ALLAMAKEE CSD MIDDLE SCHOOL HVAC UPGRADE
WAUKON, IOWA

ADDENDUM 02
March 6, 2026

M-801

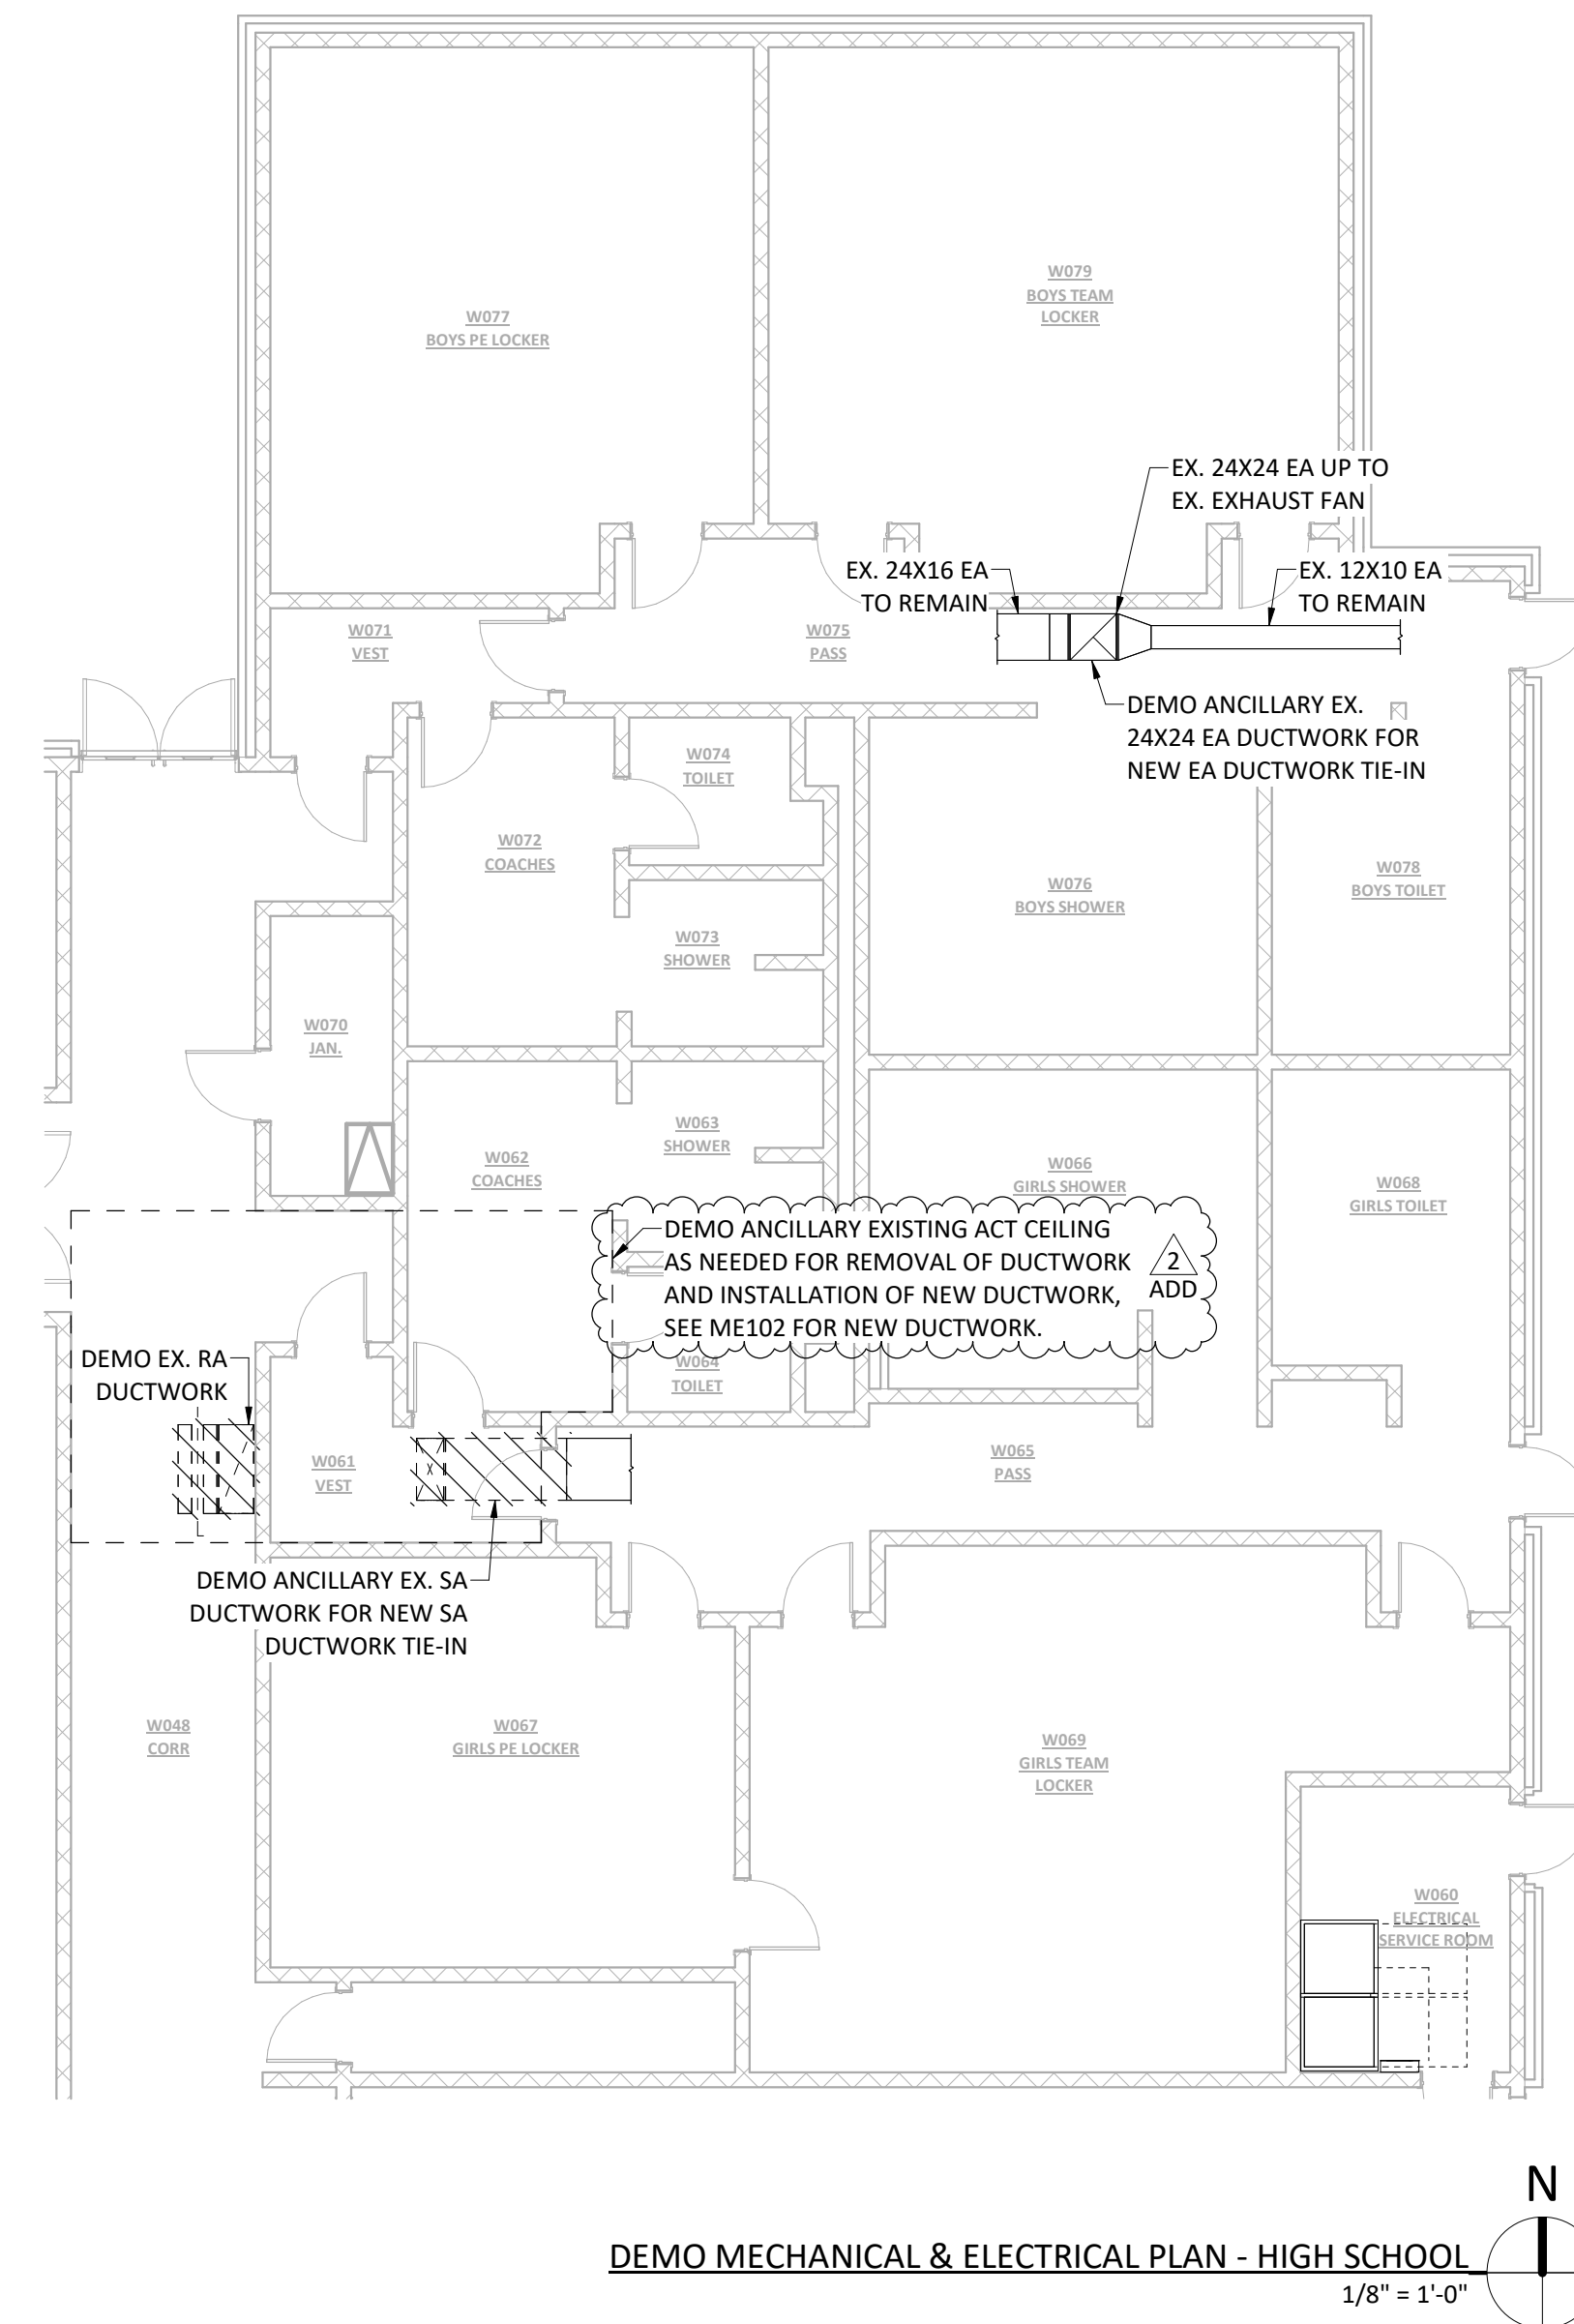
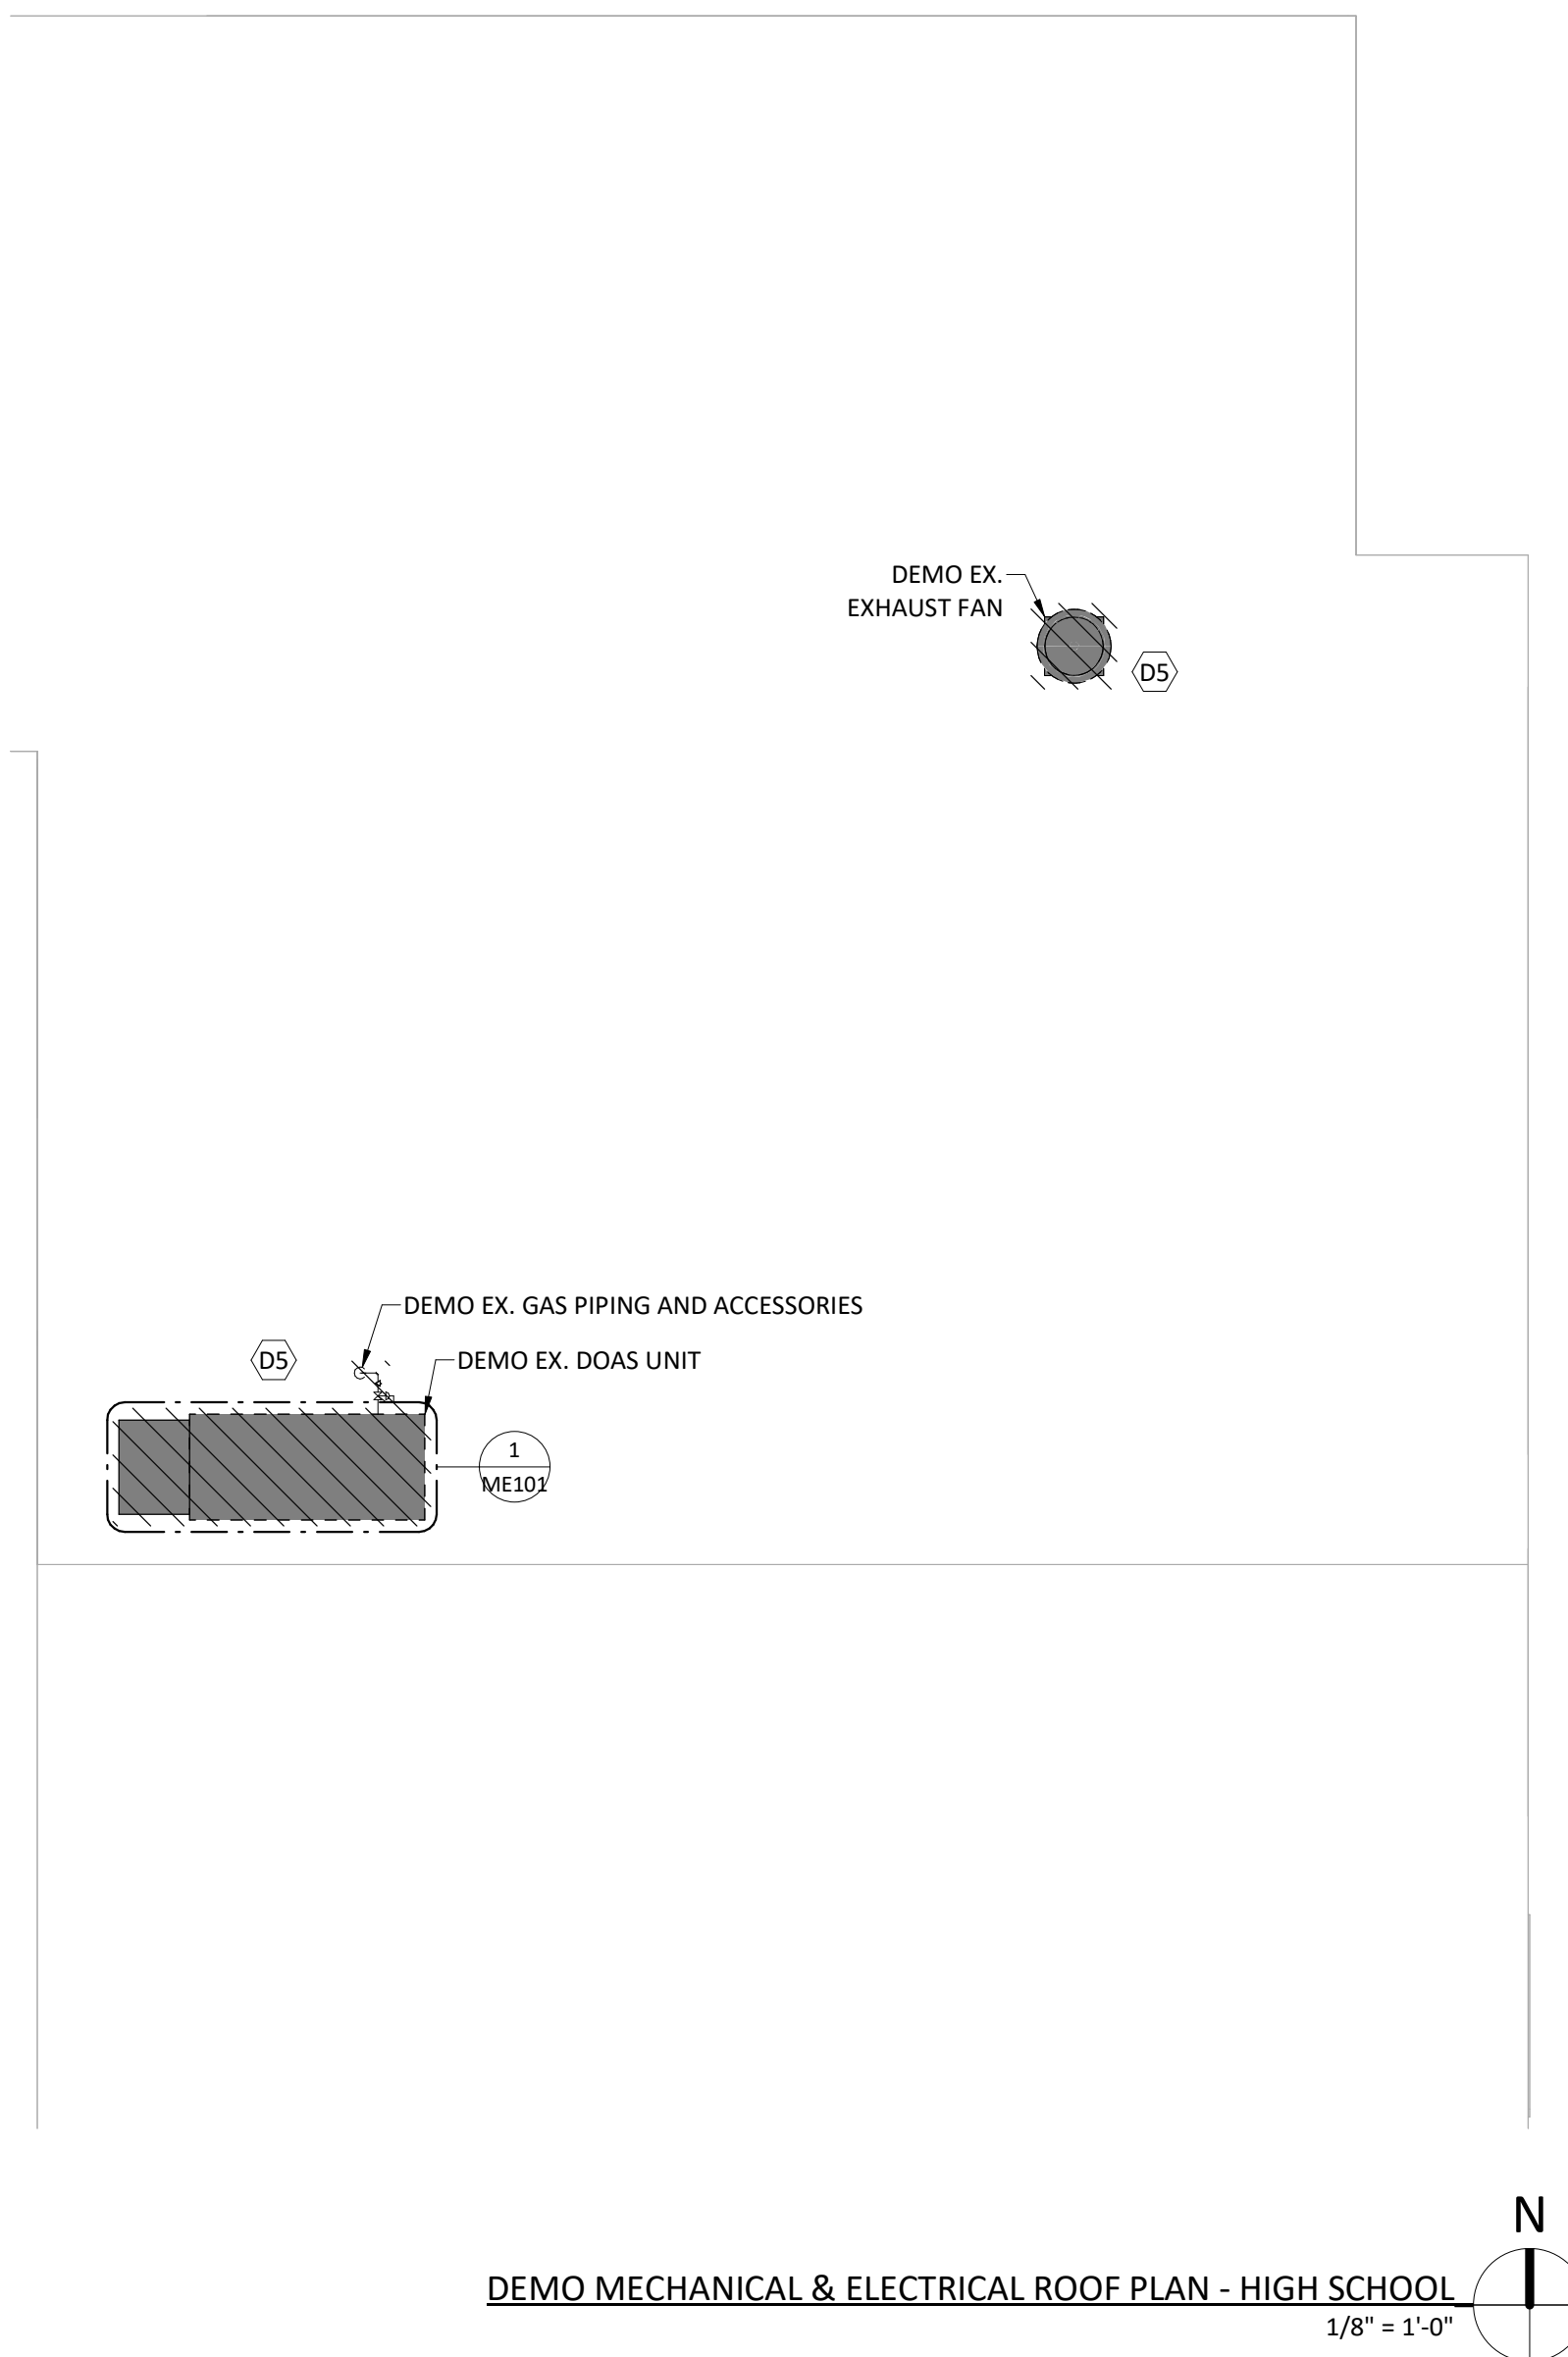
1. Added DOAS Control Diagram for hot water heating units.
 2. Removed not 6 & 10 from gas-fired DOAS Control Diagram sequence.
- ME2-1 Drawing **ME101 – DEMO MECHANICAL & ELECTRICAL PLANS – HIGH SCHOOL**

MECHANICAL & ELECTRICAL PLANS - HIGH SCHOOL

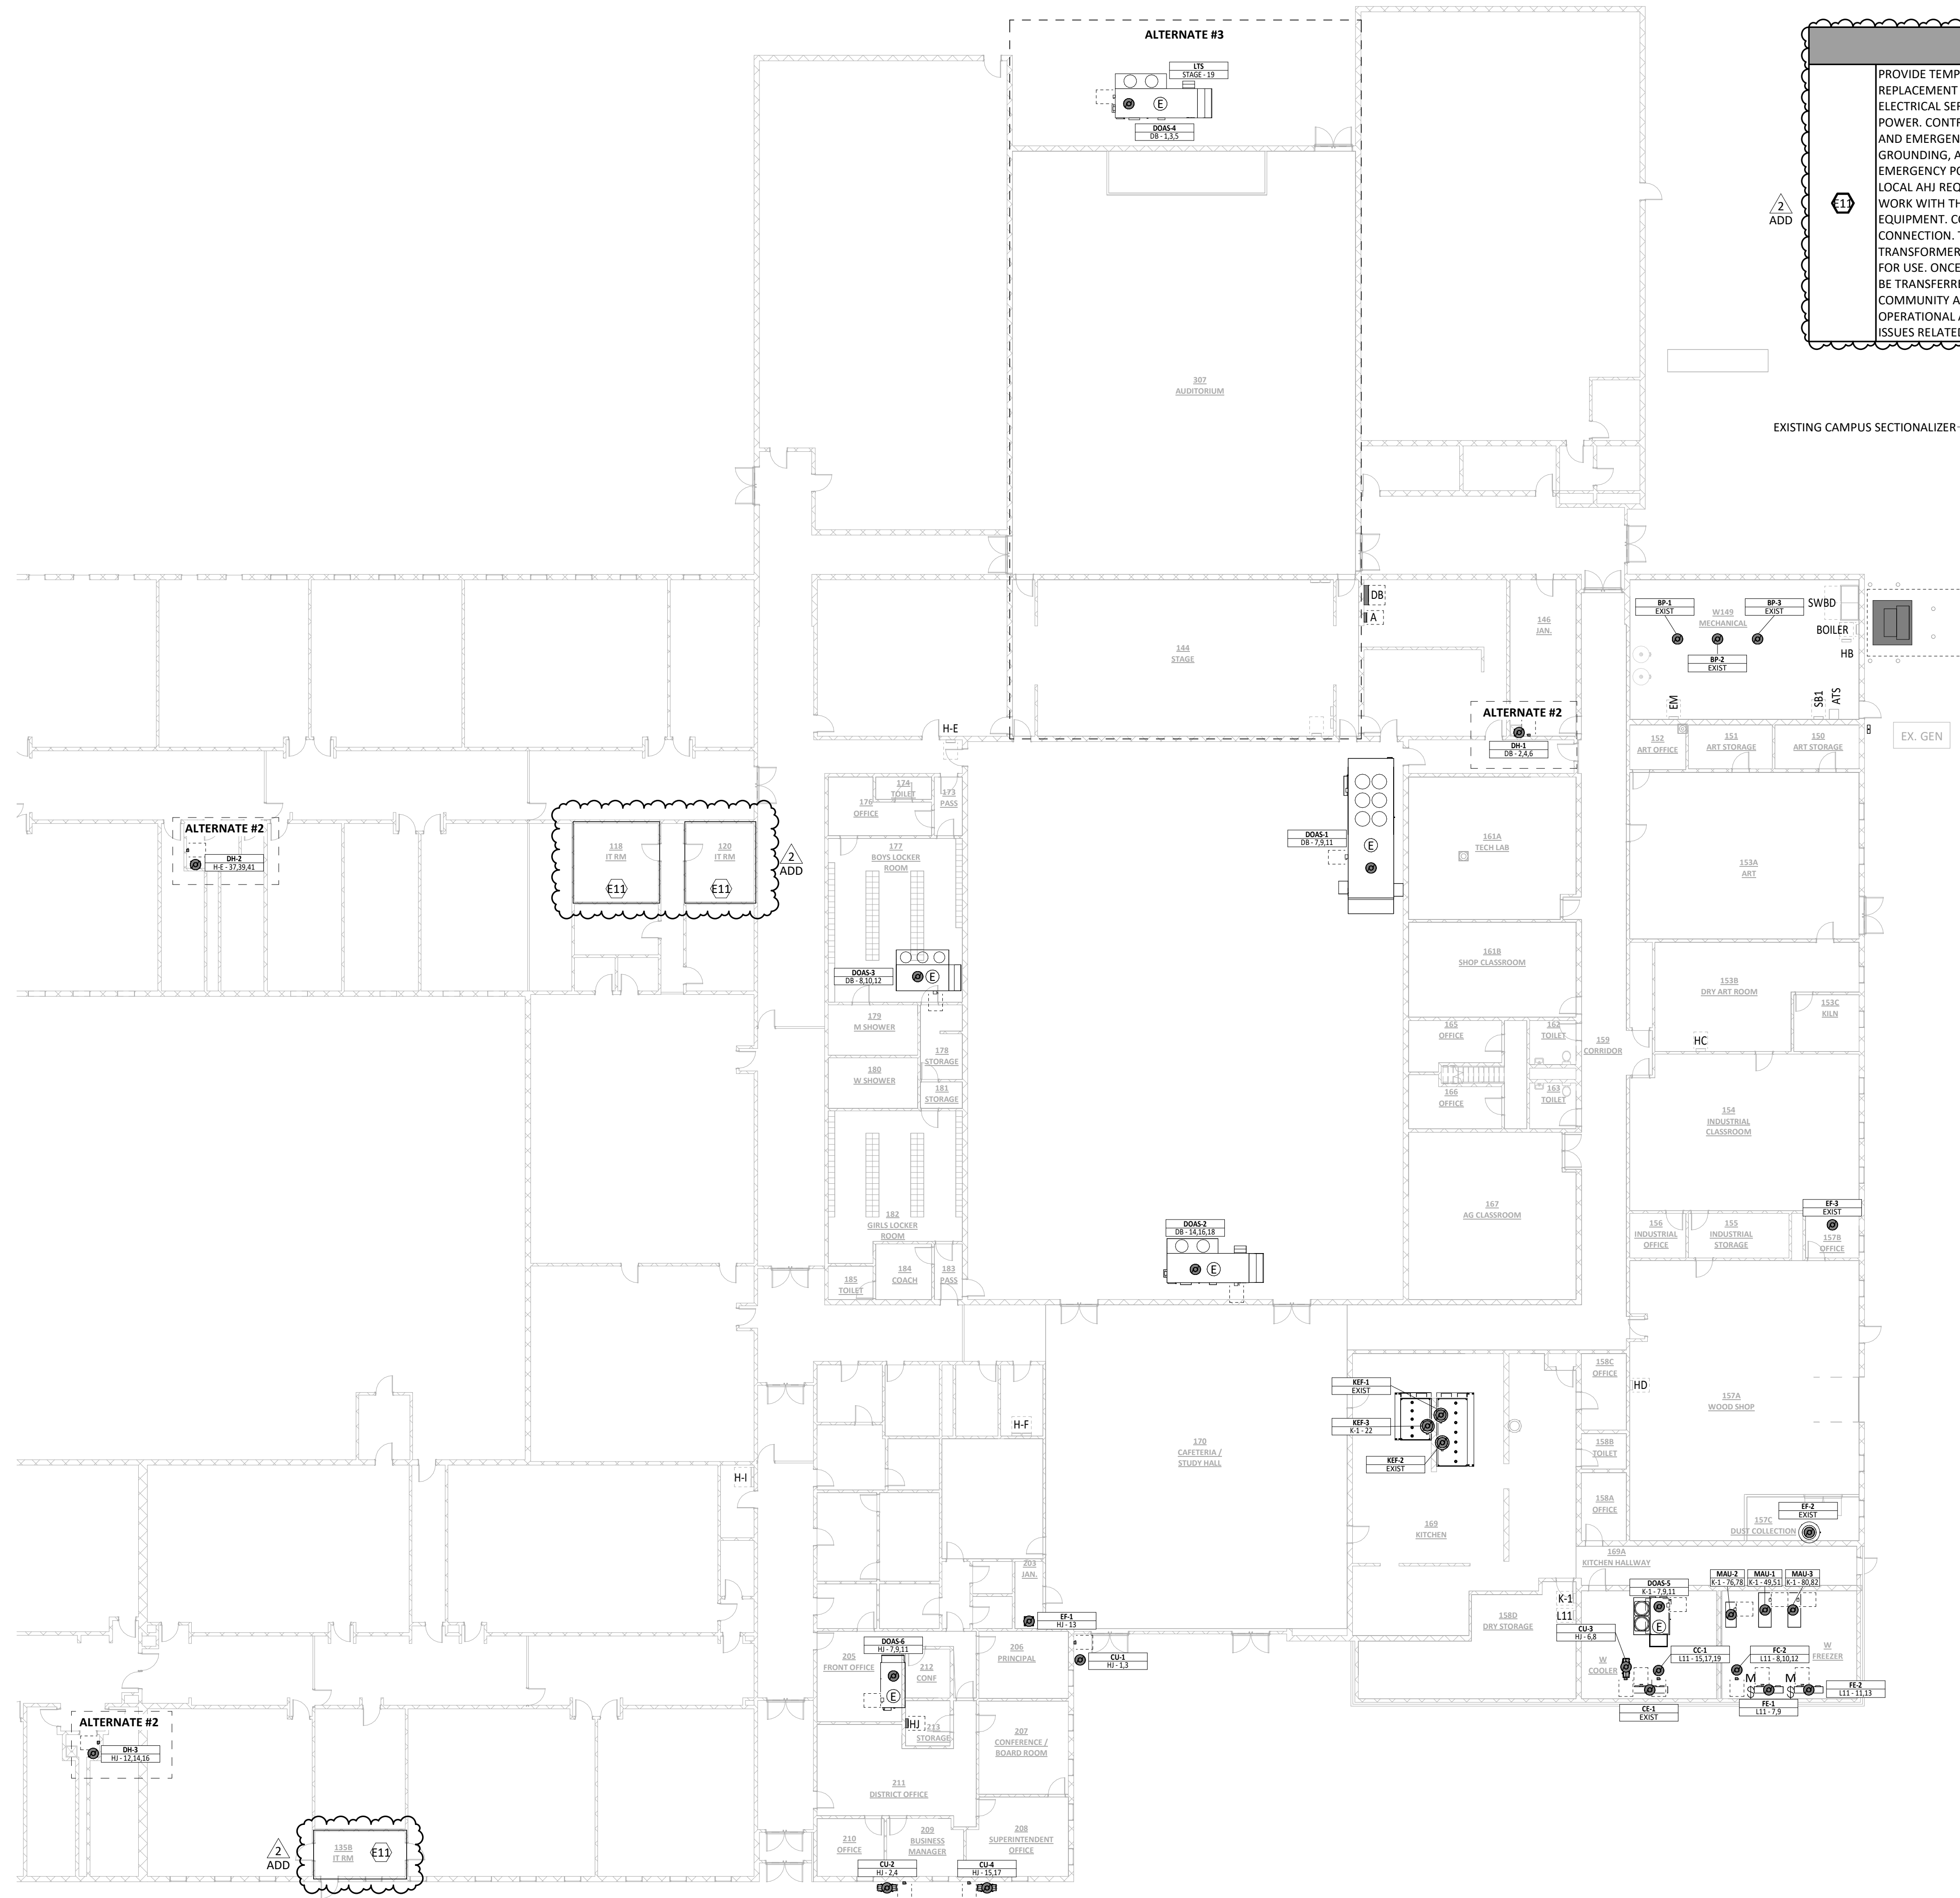
1. Added demo note for ceiling work.
- ME2-2 Drawing **ME102 – MECHANICAL & ELECTRICAL PLANS – HIGH SCHOOL**
1. Revised DOAS-1 to DOAS-7.
 2. Revised EF-1 to EF-4.

3. Added note for new ACT ceiling.
- E2-1 Drawing **E-101 – ELECTRICAL PLAN – OVERALL**
1. Added keynote for providing temp and emergency power for ICN and district IT rooms.
